Re: ACP 324277 – Response to Cork County Council’s Report on the Substitute Consent Application at Ardcahan, Dunmanway, Co. Cork

RE: ARDCAHAN QUARRY - CORK COUNTY COUNCIL REPORT RESPONSE LETTER

Subject:- Ardcahan Quarry Application for Substitute Consent - Water Framework Directive Information

Figure 1 Extract from Appendix 7.2

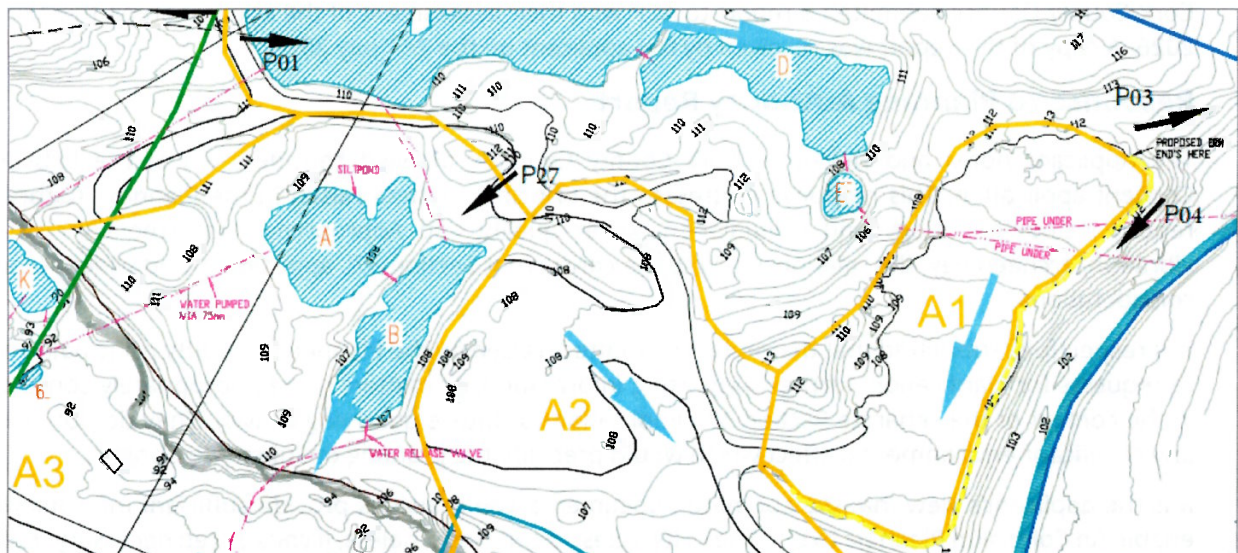
The Planning Authority notes that one of the key issues with the application relates to uncertainty regarding impacts to the water quality in the Bandon River SAC during the substitute consent period and the potential impact from the discharge of suspended solids and PAC, particularly in the context of Freshwater Pearl Mussel habitat.

The council queries the surface water run-off from the five discharge locations from the tarmac and old quarry areas and the potential impact on the adjacent stream. This is covered in Chapter 7 of the rEIAR, particularly in Section 7.2.4 and Table 7.1 which describes the site's surface water discharges and potential risk. The local topography of the site and camber of the main access road means that there is no runoff to the stream from the site area except for the five identified discharge points.

This wash water was pumped up gradient into Pond A which had a large capacity and could also overflow to Pond B if necessary, which ensured sediment settlement and that no particulates were re-circulated down to the ponds in the lower part of Catchment Area 3. The use of PAC flocculate helped ensure that any fine particulates from the washing activities, were rapidly taken out of suspension when discharged into Pond A.

The EIAR identifies 'Area A1', located in the north-east corner of the site, as a sludge disposition site. There is no direct linkage to a discharge point from this Area A1 and as such the potential impact on the surface water in the area is identified as 'low'.

As noted above, the use of PAC on site allowed the suspended solids to be removed from the settlement ponds prior to any discharge from site. The silt created from these suspended solids was then contained on site. The settlement ponds A & B are dry and have naturally revegetated since quarry activity ceased.

Figure 2 1995 Aerial Photography: Extraction Area as of 1995 outlined in red (extraction prior to 1990, shaded purple)

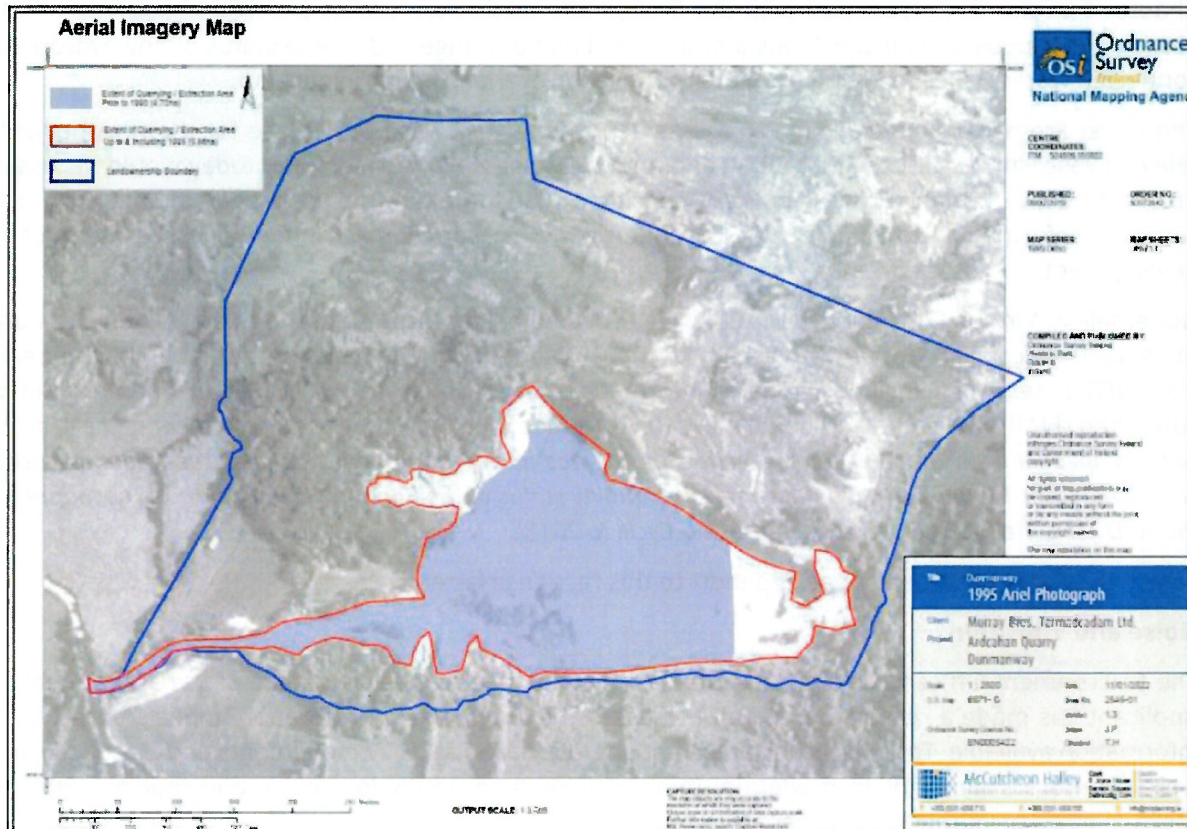
The Ecology Officer acknowledges that no significant negative ecological effects would be likely to arise following implementation of the proposed remediation measures, but suggests that the remediation proposals are limited in scope and do not demonstrate sufficient compensation for the damage that has occurred since 1990.

It should be noted that initial extraction activities that took place at the Site pre-1963, prior to the substitute consent period of 1990 to 2014. See Figure 2 above. Most of the vegetation clearance works that resulted in a loss of habitat pre-1995 are not subject to assessment within this substitute consent application.

ARDCAHAN QUARRY COMBINED SUBSTITUTE CONSENT REMEDIATION AND S37L REGENERATION PLAN

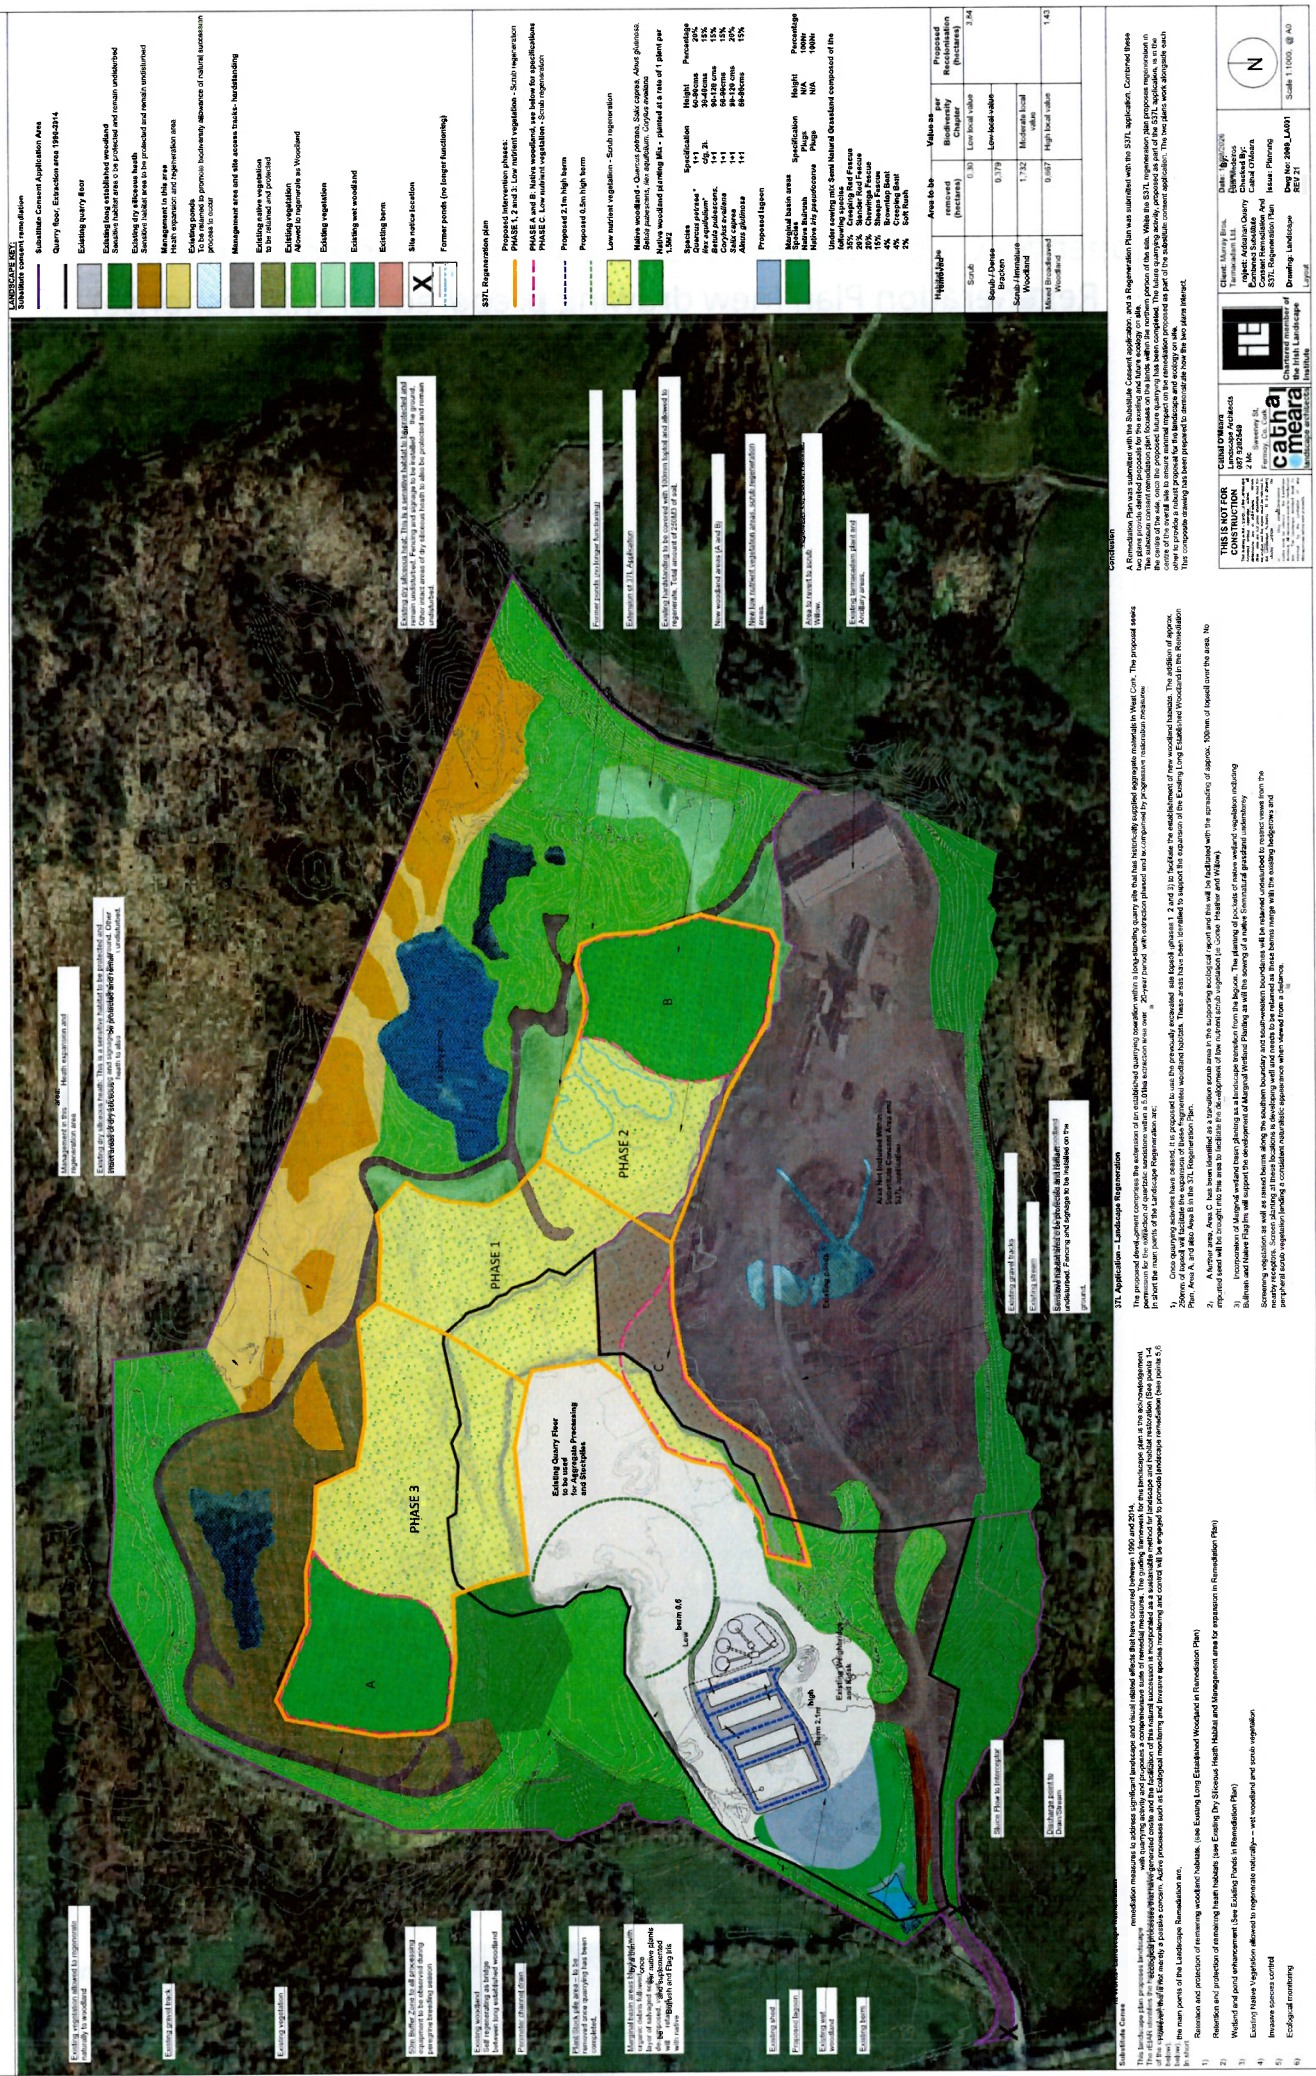
Furthermore, several of the mitigation measures referred to by the Ecology Officer relate to the concurrent Section 37L application and future quarrying activities rather than the historic quarrying development that is the subject of the Substitute Consent application. These matters are more appropriately considered within the context of the Section 37L application.

A Remediation Plan was submitted with the Substitute Consent application, and a Regeneration Plan was submitted with the S37L application. Combined these two plans provide detailed proposals for the existing and future ecology on site. To demonstrate how the two plans interact, a composite drawing has

been prepared and is submitted as part of this response. A copy Regeneration Plan, the Remediation Plan, and the composite drawing, are provided as appendices to this letter.

Scaled Map Identifying Each of the Nearest Noise Sensitive Receptors at Distances Of 500m & 1 km From the Nearest Development Boundary in Each Direction

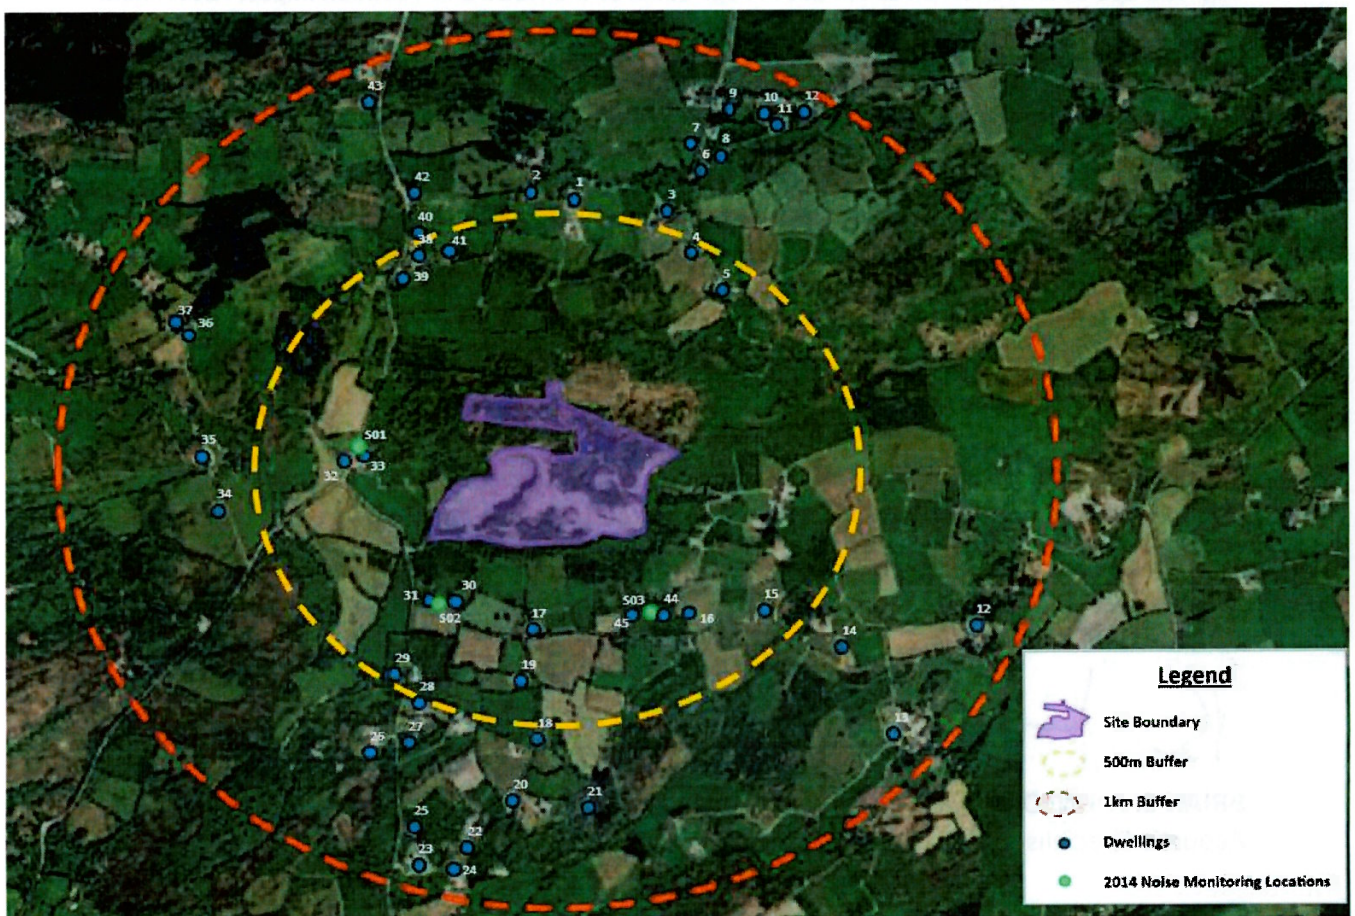
1.) The respective number and distances of all noise sensitive receptors within 500m and 1000m of the proposed development should be presented and quantified. The referenced noise sensitive receptors that each selected noise monitoring location is considered to be representative of should also be identified and quantified and shown on a suitably scaled map.

The differing receptor distances appear to arise from differing measurement approaches and receptor definitions, including property boundaries, dwellings and noise-sensitive receptors. CLV Consulting have provided an updated map and have clearly set out the distances from the noise survey locations and the nearby dwellings. Please see their letter response for further detail.

A scaled map identifying each of the nearest noise sensitive receptors within 500m and 1km of the substitute consent application is provided in Appendix A at the rear of this document. The map also includes the 2014 noise monitoring locations (S01, 02 & 03).

Figure 1: Hydrological Features including the local catchment area of the adjacent 'Boundary Stream'.

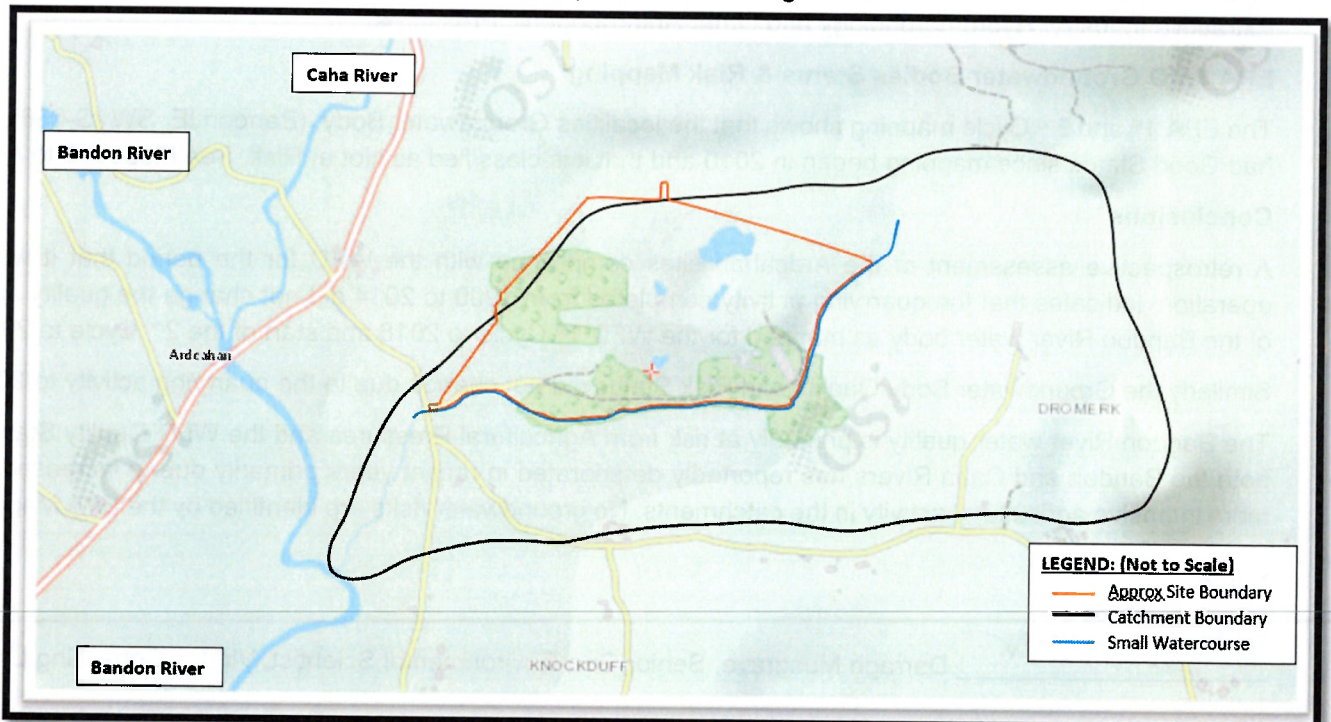
The Applicant notes the request for a Water Framework Impact Assessment and associated monitoring information. It is submitted that the application is accompanied by a detailed Hydrology and

The main hydrological feature near the site is a small unnamed stream that flows along the sites eastern and southern boundaries. This small watercourse, (identified as the boundary stream), has an estimated catchment area of about one square kilometre (1km²) of which the site area occupies approximately 25%. The remainder of the catchment is occupied by upland agricultural grassland and scrub vegetation.

The stream flows adjacent to the site close to its eastern and southern boundaries and reaches the Bandon River about 500m to the southwest of the quarry site. Refer to Figure 1.
